REQUEST FOR FINAL ACTION – EVALUATION 2017-15516 – HEAT RATE INPUT CALCULATIONS

HEAT RATE INPUT CALCULATIONS

Evaluation 2017-15516
June 30, 2018

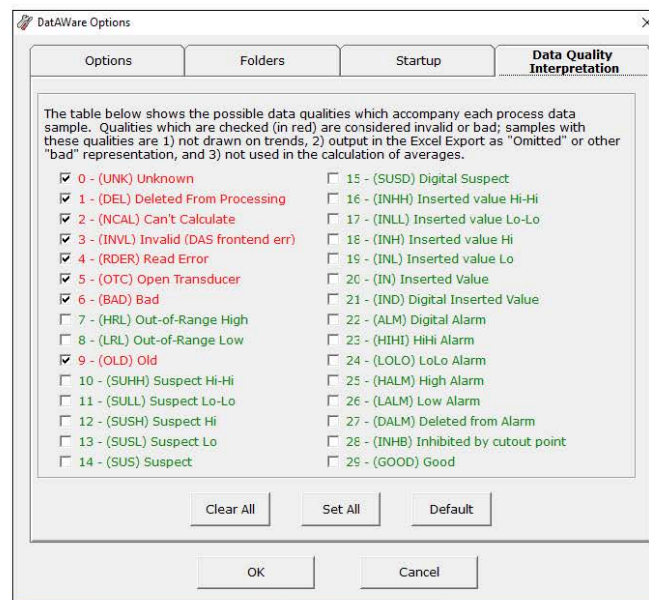
- Determine and document appropriate settings to be utilized in coal plant hourly reference heat rate calculations.

The coal plant calculations involve extracting unit data using a software called DatAWare, a data historian. The data collection settings in DatAWare will be documented in the procedure for data collection, *CO-SPP-09.050.01 – Operating Statistics & Station Economy Report Procedure*, by September 30, 2018. The settings are shown below:
